AGENDA

President and Board of Trustees
Village of Arlington Heights
Board Room

September 21, 2015

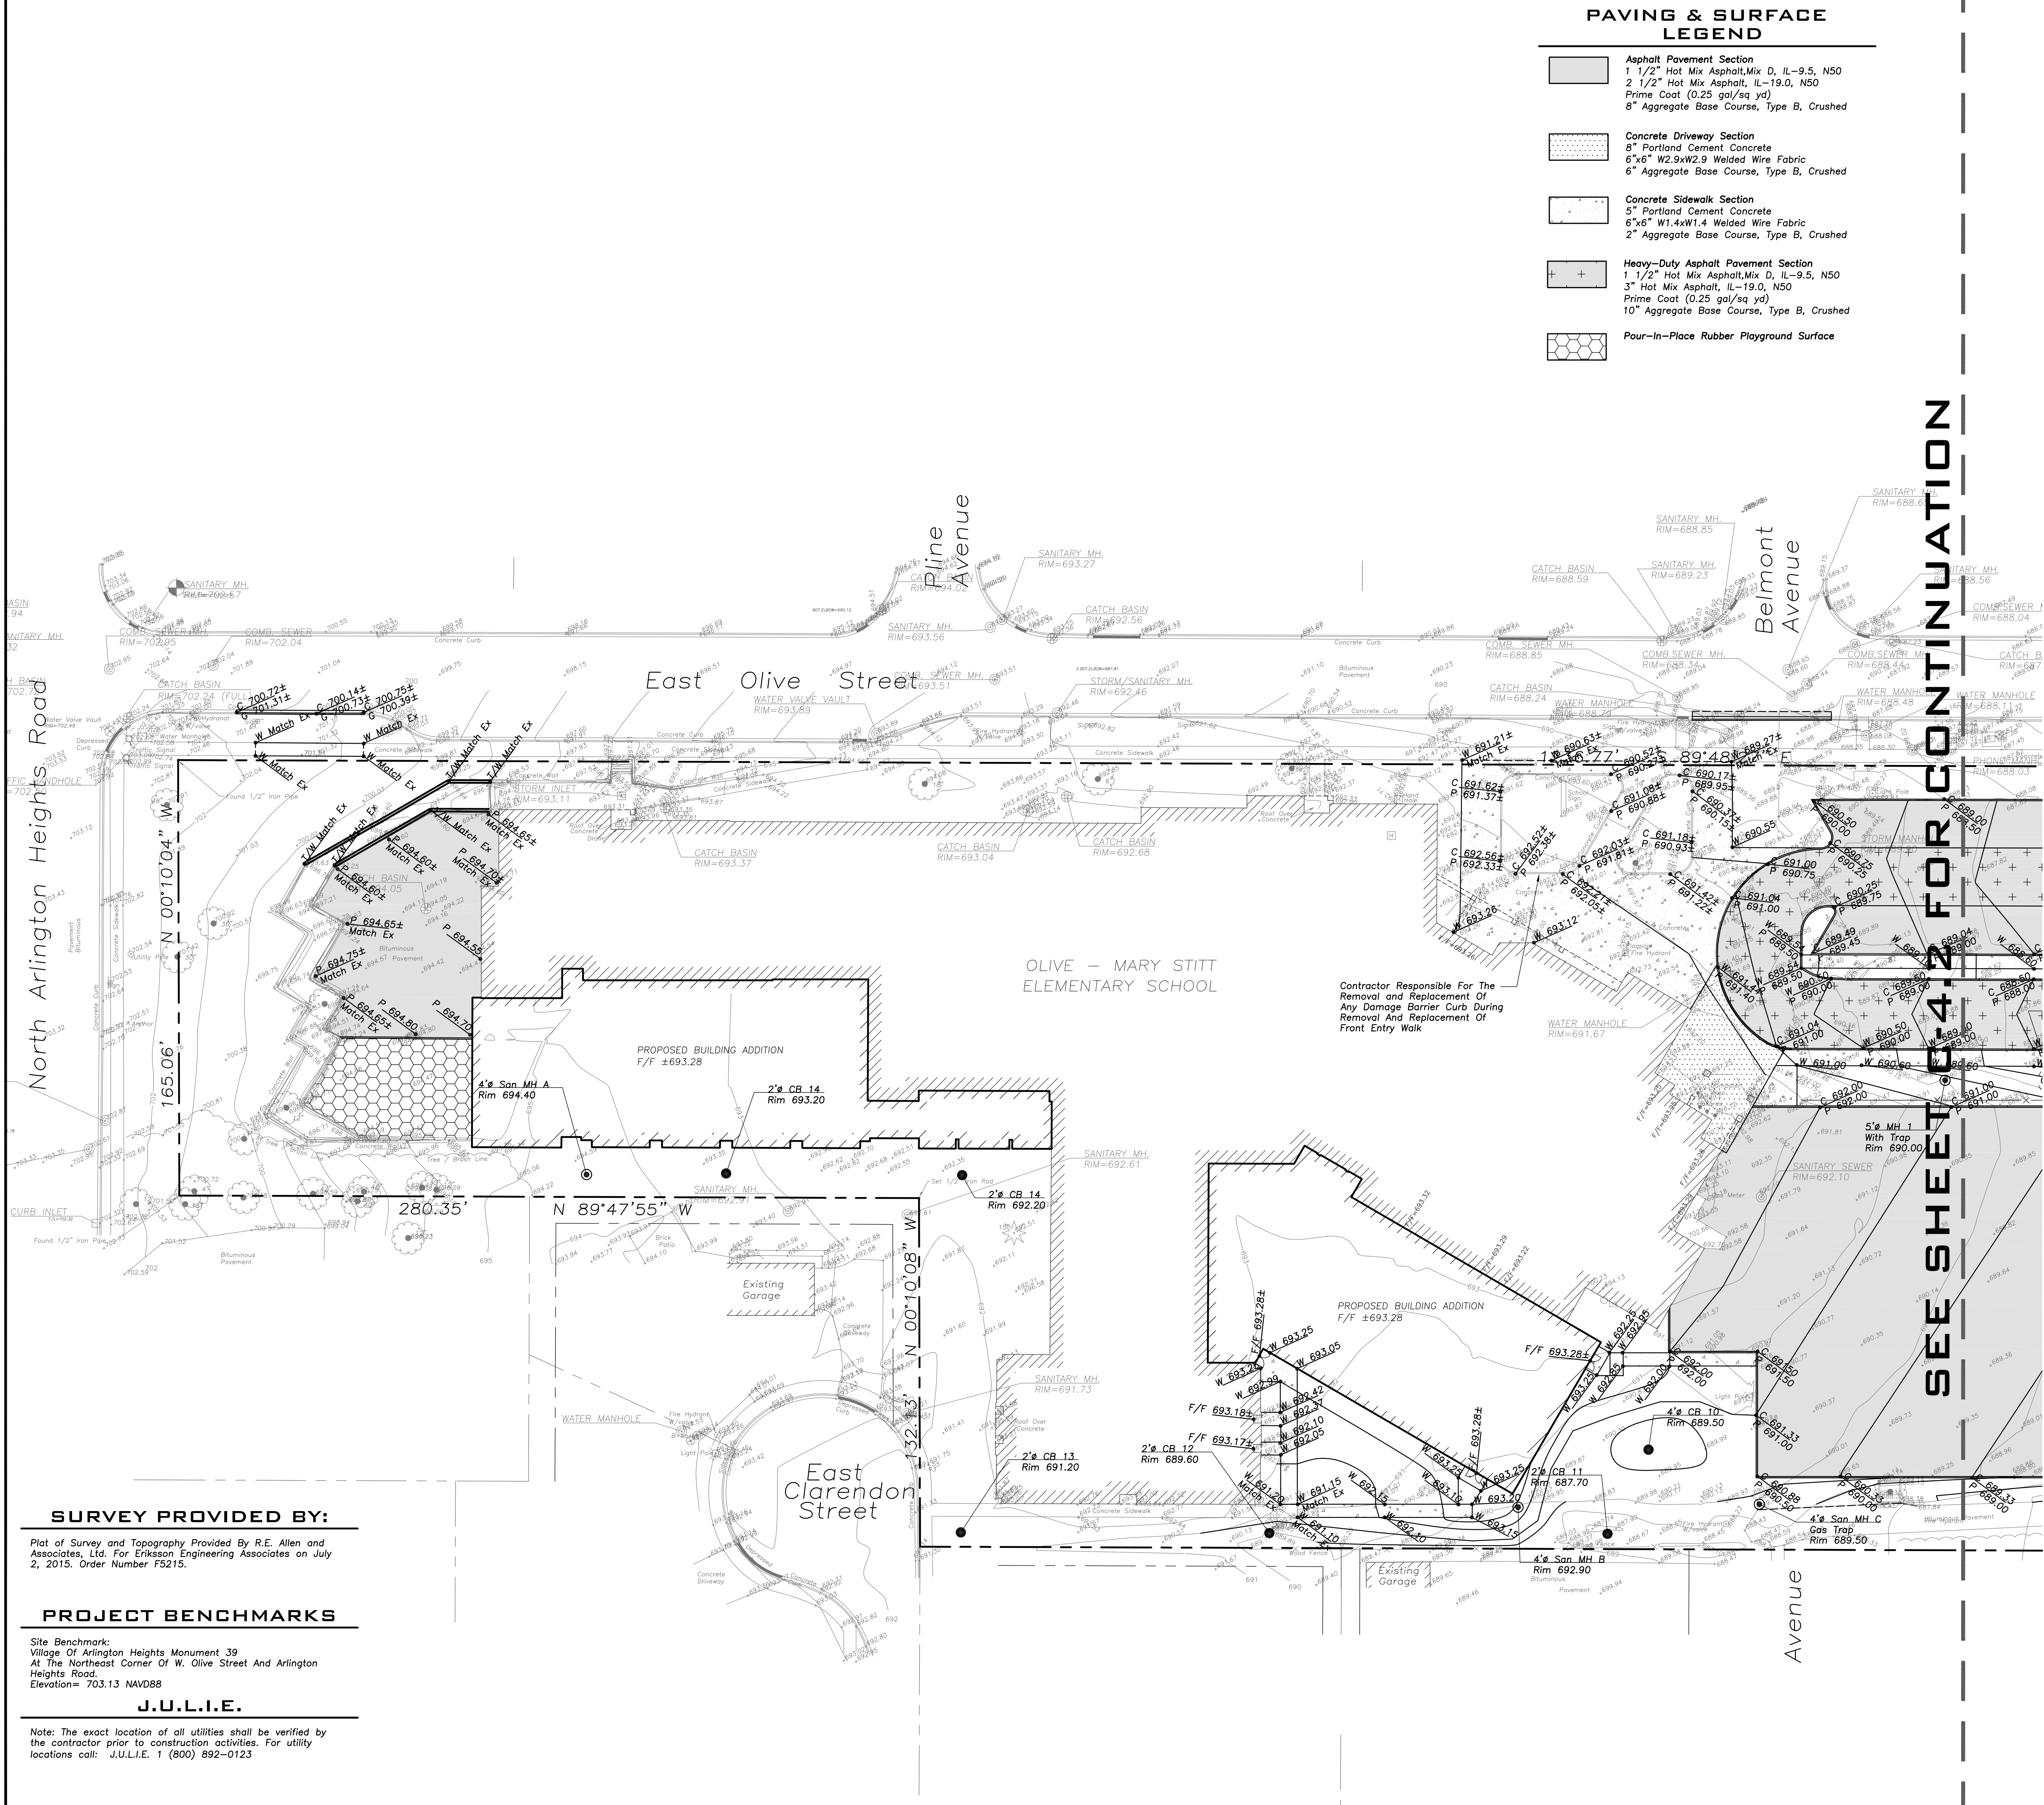
22. Sheet C-3.1: The sanitary sewer connection shown for the west addition is not acceptable. As was previously communicated, portions of the existing sanitary sewer within the public easement are not public but privately maintained. The nearest public sanitary manhole is immediately northeast of the Clarendon Street cul-de-sac behind the sidewalk. On the drawing, the manhole is labeled as an existing sanitary manhole, Rim=691.73, 8" Inv=685.07.

23. Sheet C-3.1: Provide conflict elevations for where the new sanitary sewer from the east building addition crosses the existing 10" public water main in the vacated Belmont Avenue corridor. Similarly, provide conflict elevations for the proposed storm sewer where it crosses the existing utilities. The existing sanitary service is shown to connect to the storm relief sewer...Is this shown correctly?

Sheet No:
C-4.1

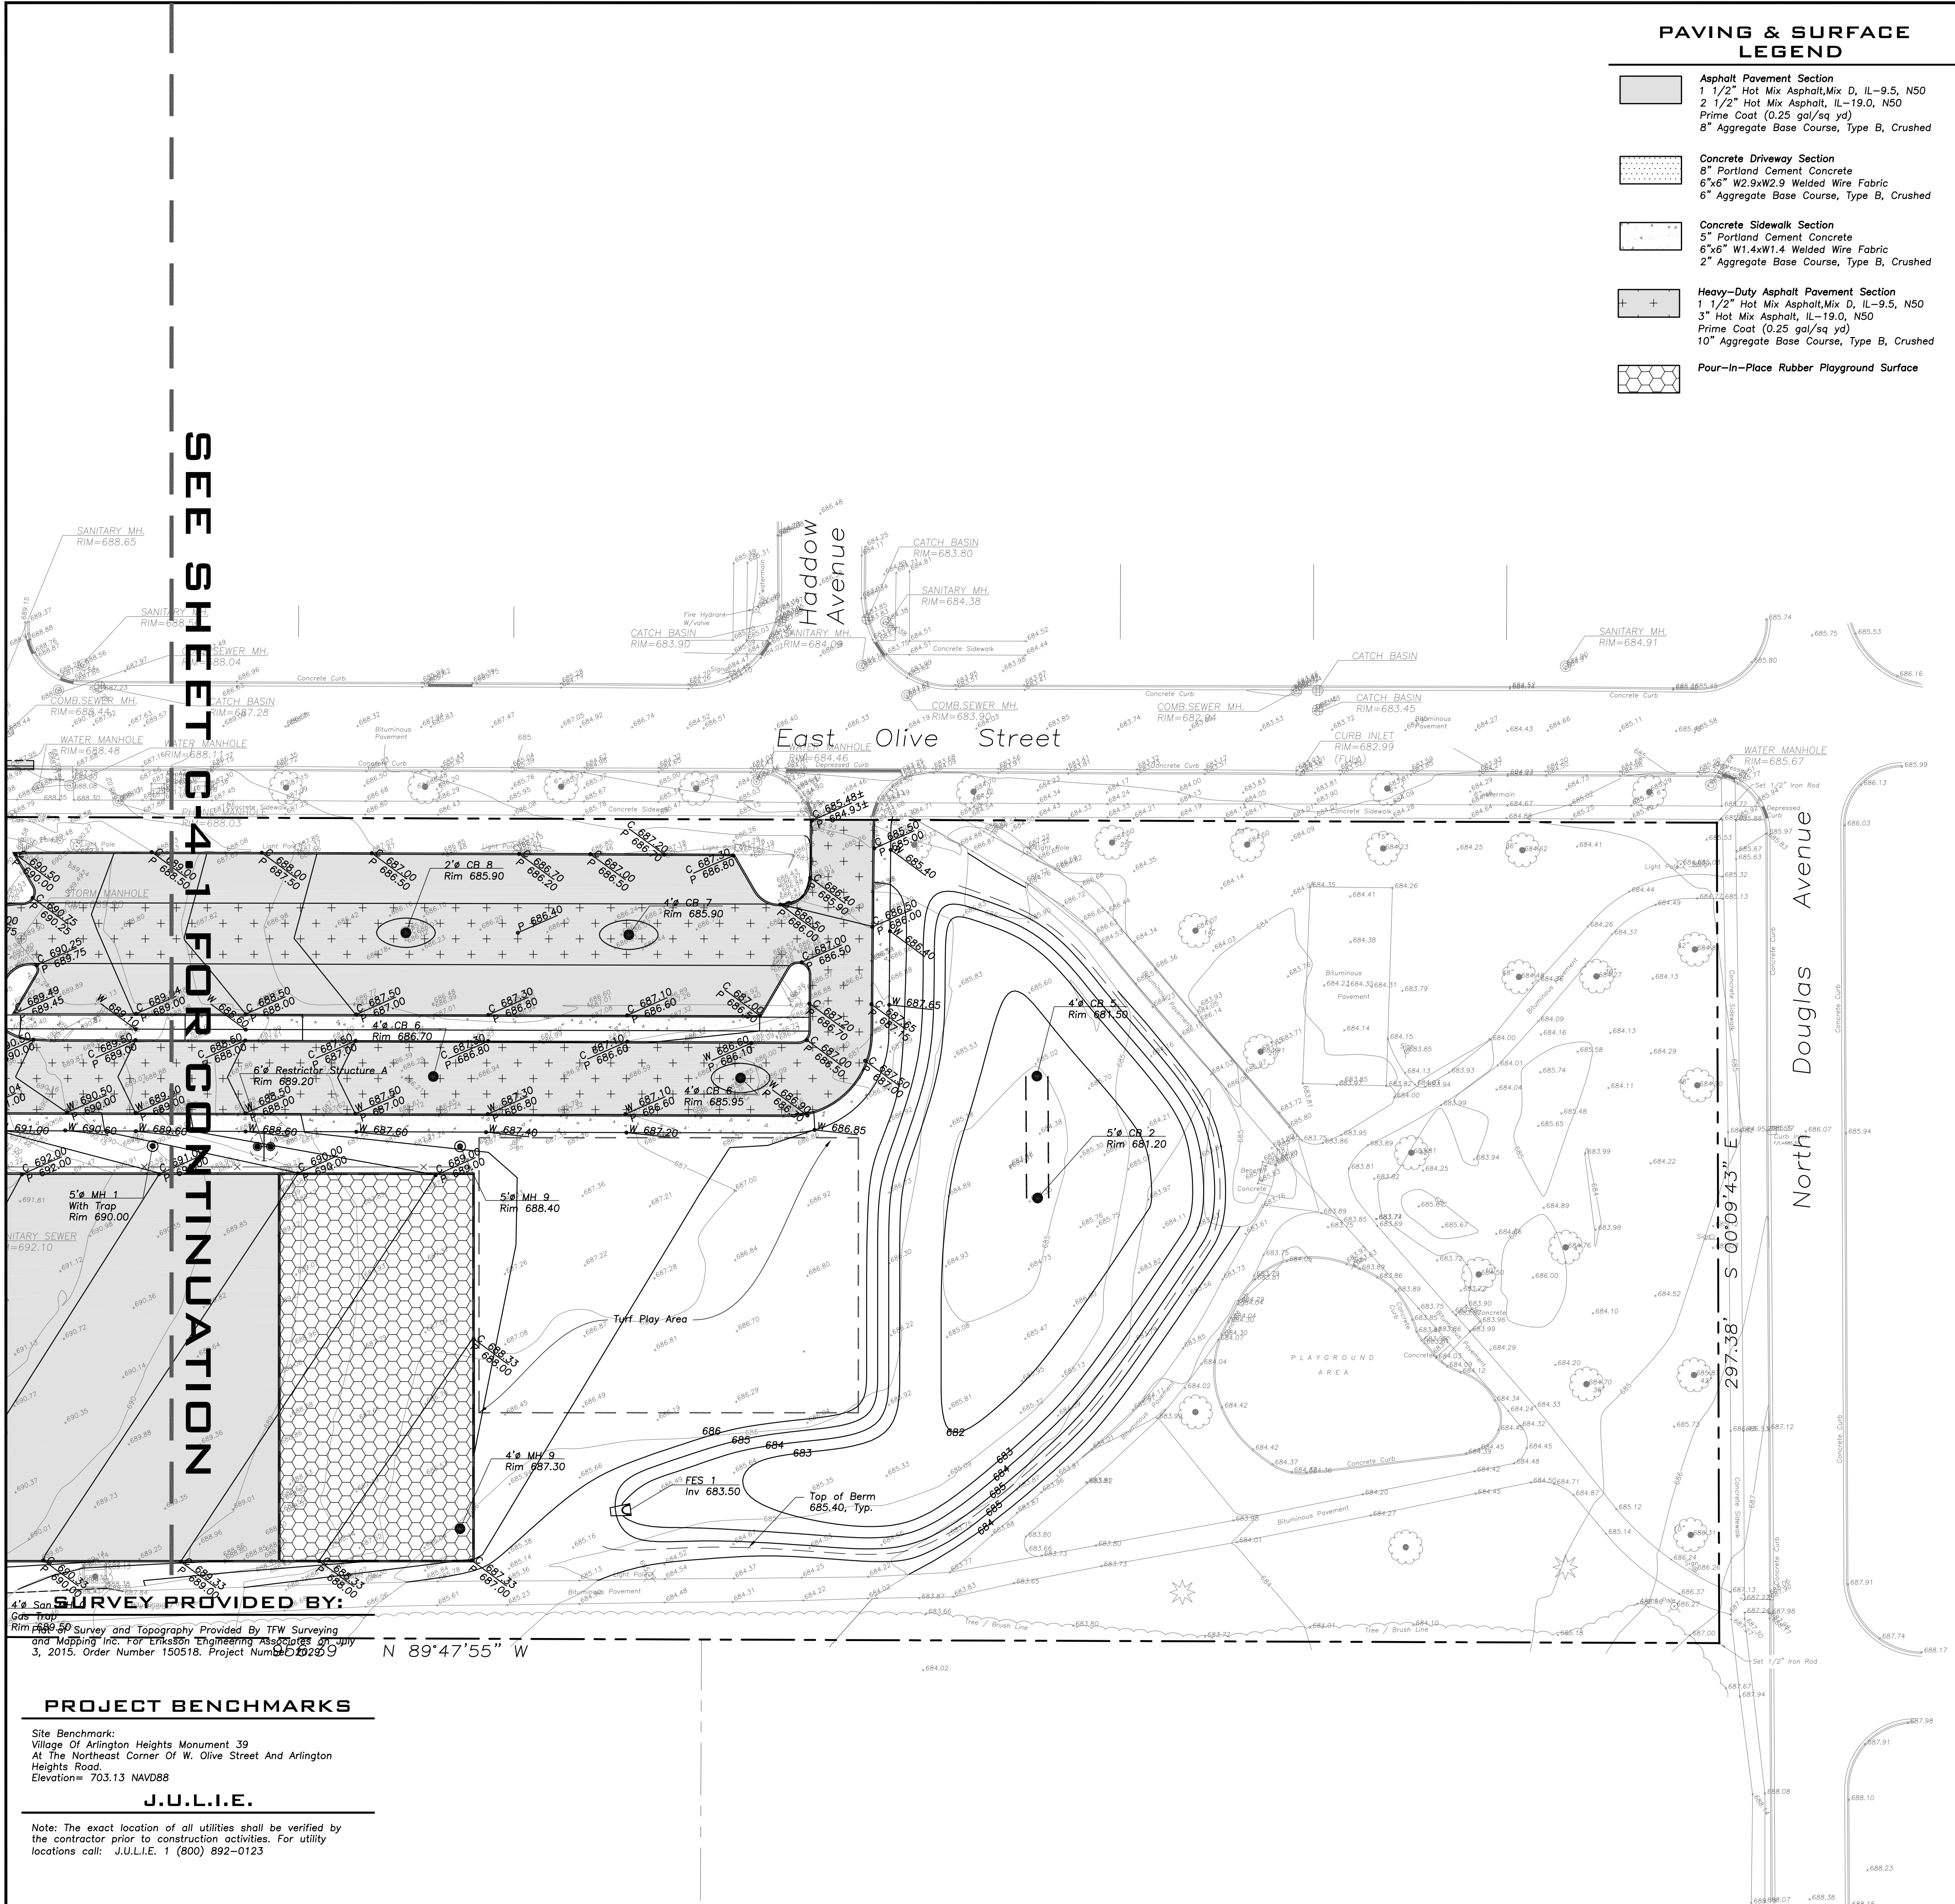
24. Sheet C-4.1: The grade at the south corner of the new gym drops off steeper than 5:1 along the property line and any runoff from the slope will be directed to the neighbor's lot. Review this area for re-grading.
